## SOMNIO GLOBAL PARKING EXPANSION JSP21-26

### **Approval – Revised Preliminary Site Plan**

# PLAN REVIEW CENTER REPORT

## Planning Review Somnio Global - Parking JSP 21-26

**SITE PLAN**

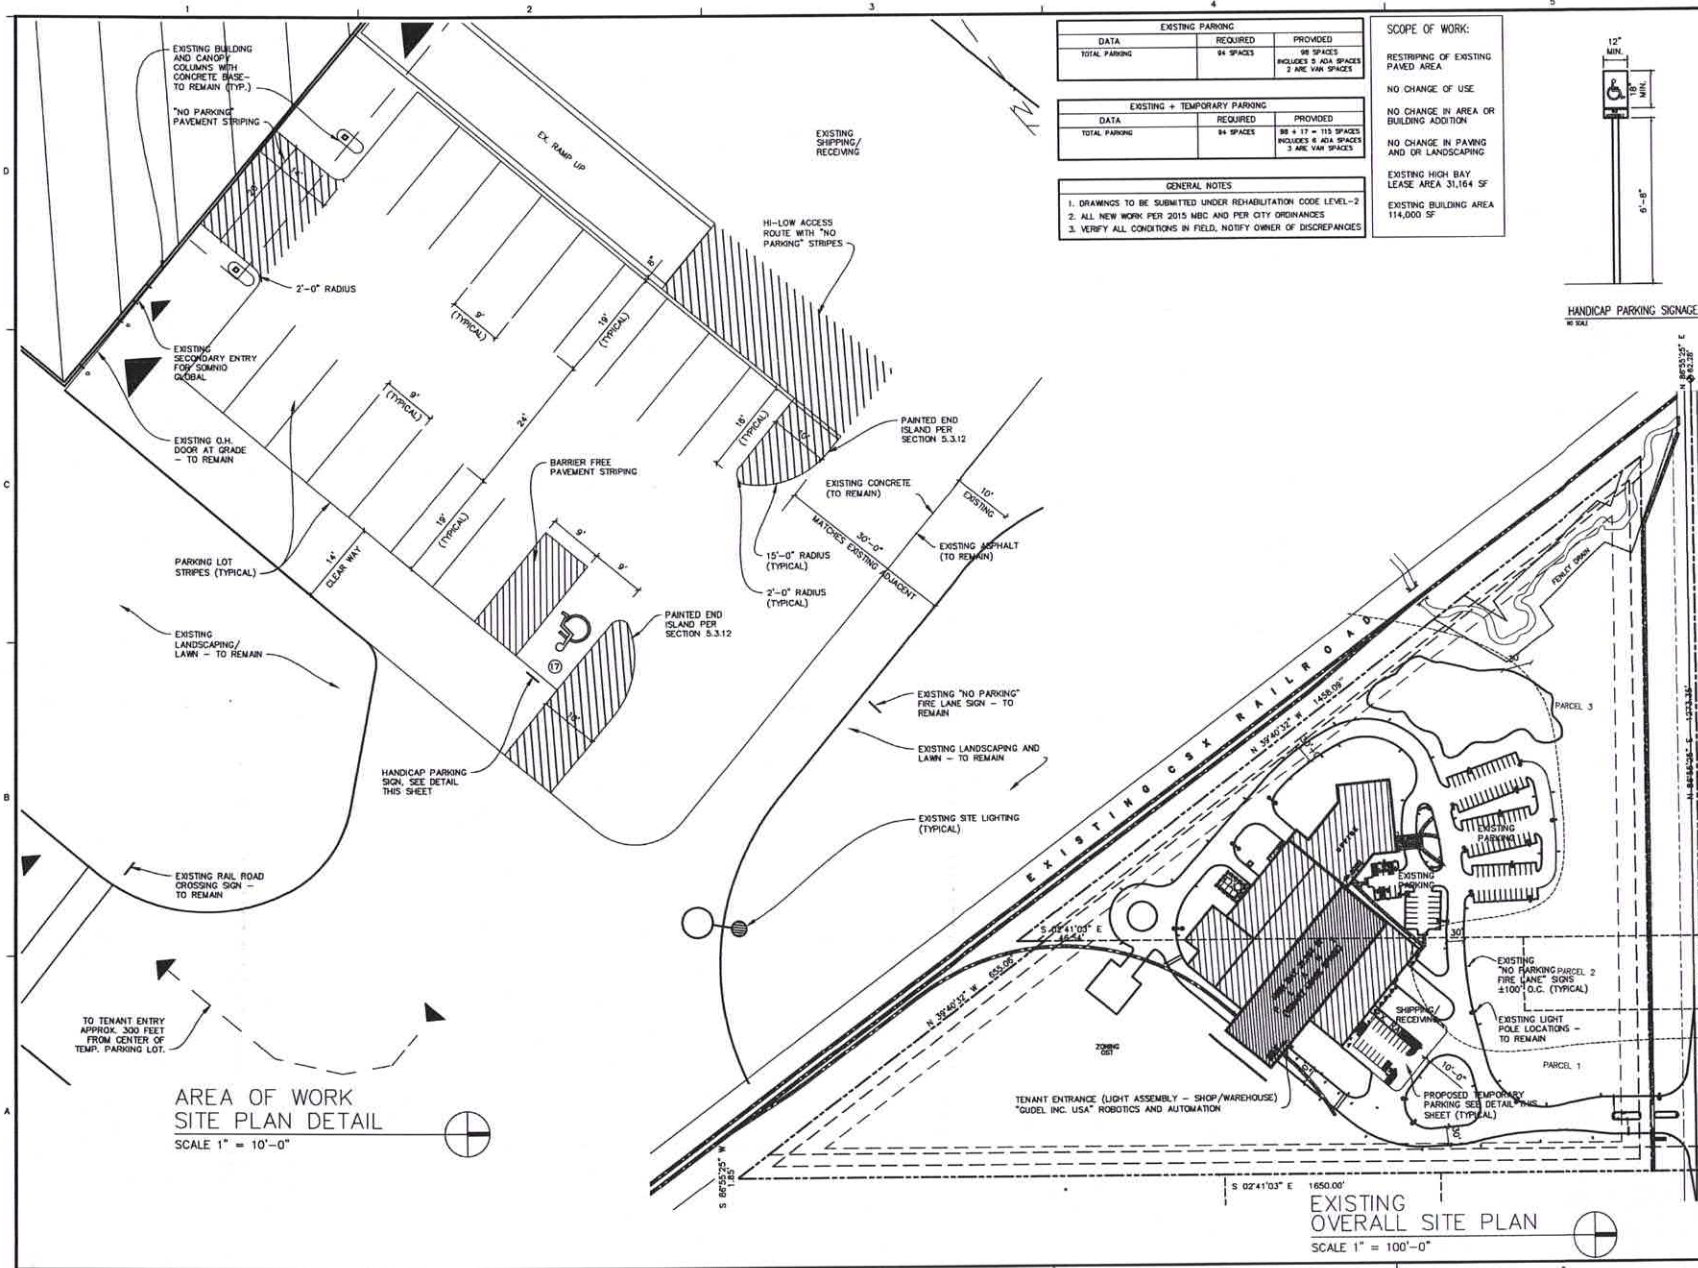
2. End Islands (Sec. 5.3.12): End islands with raised curbs and landscaping are required at the end of all parking bays that abut traffic circulation aisles in off-street parking lots. For surface lots where internal traffic circulation is forecast to be low or where raised islands would not be appropriate, the Planning Commission may waive the requirement for raised islands and may allow for painted islands only. The end islands, whether raised or painted, shall generally be at least 10 feet wide, have an outside radius of 15 feet, and be constructed 3 feet shorter than the adjacent parking stall (see image below). Staff supports the waiver to allow the end islands to be painted given the intent that the parking be temporary. **The current plan shows the painted islands to be 2 feet wide. Revise the painted end islands to meet the dimensional requirements of the ordinance, or seek a variance from the Zoning Board of Appeals.**

3. Barrier Free Parking: Federal ADA law requires accessible parking spaces for each parking facility on a site, such as lots and garages. Requirements apply equally to public and employee or restricted parking. On sites with multiple parking facilities (or separate parking lots), the minimum number of accessible spaces must be calculated separately for each parking facility instead of on the combined total of parking spaces provided on the site. **The applicant should provide the minimum of one barrier-free space for this parking lot.**
4. Building Permit: A Building Permit may be required for this project. Please contact the Building Department to determine what is required.
5. Planning Chart: Please refer to the attached Planning Chart for additional comments to address in the next submittal.

<b>Parking Space Dimensions and Maneuvering Lanes</b> (Sec. 5.3.2)	- 90° Parking: 9 ft. x 19 ft. - 24 ft. two way drives - 9 ft. x 17 ft. parking spaces allowed along 7 ft. wide interior sidewalks as long as detail indicates a 4" curb at these locations and along landscaping	9 ft. x 19 ft. 90° spaces with 24 foot access aisle;	Yes	
<b>Parking Ingress/Egress</b> (Sec. 5.3.4)	- Adequate ingress and egress to the parking lot by means of clearly limited and defined drives	Drives areas do not cross residential districts	Yes	
<b>Parking stall located adjacent to a parking lot entrance</b> (public or private) (Sec. 5.3.13)	- shall not be located closer than twenty-five (25) feet from the street right-of-way (ROW) line, street easement or sidewalk, whichever is closer	Not applicable	NA	
<b>End Islands</b> (Sec. 5.3.12)	- End Islands with landscaping and raised curbs are required at the end of all parking bays that abut traffic circulation aisles. - The end islands shall generally be at least 10 feet wide, have an outside radius of 15 feet, and be constructed 3' shorter than the adjacent parking stall as illustrated in the Zoning Ordinance	2' Striping at the end of the aisle proposed	No	<p><b><u>Painted islands must have same dimensions as raised islands – or ZBA variance would be required</u></b></p> <p><b>Due to temporary nature of the parking, painted end islands may be used in lieu of curbed/landscaped islands – Planning Commission would need to approve the waiver</b></p>

<b>Barrier Free Spaces</b> <i>Barrier Free Code</i>	1 barrier free parking spaces are required (for total 18 spaces)	No BF spaces proposed	<b>No</b>	<i>Accessible parking spaces must be located on the shortest accessible route to an accessible entrance</i>
<b>Barrier Free Space Dimensions</b> <i>Barrier Free Code</i>	- 8' wide with an 8' wide access aisle for van accessible spaces - 8' wide with a 5' wide access aisle for regular accessible spaces			
<b>Barrier Free Signs</b> <i>Barrier Free Code</i>	One sign for each accessible parking space.			
<b>Loading Spaces</b> <i>(Sec. 5.4.1)</i>	Loading space shall be provided in the rear yard or in the case of a double frontage lot, interior side yard, in ratio of 5 sf/front foot of building up to total of 360 sf/building	Converting existing loading area to parking	<b>Yes?</b>	<b>New tenant will have indoor loading area</b>
<b>OST District Required Conditions (Sec 3.20)</b>

1. Per City Zoning Ordinance, painted islands will require a waiver from the Planning Commission.
2. The 2-foot-wide painted end islands do not conform to the City standard island design and shall be revised (i.e. 2' minor radius, 15' major radius, minimum 10' wide, 3' shorter than adjacent 19' stall). Consider shortening the 20-foot-long striping proposed adjacent to the building to transfer the additional 8 feet of width required for the painted islands.

1. Parking End Islands – The plan has been revised as per section 5.3.12 to meet the dimensional requirements of the ordinance at a width of 10'. See attached amended plan. We are therefore not seeking a variance from the zoning board of appeals,
2. Barrier Free Parking – One barrier free parking spot has been included.
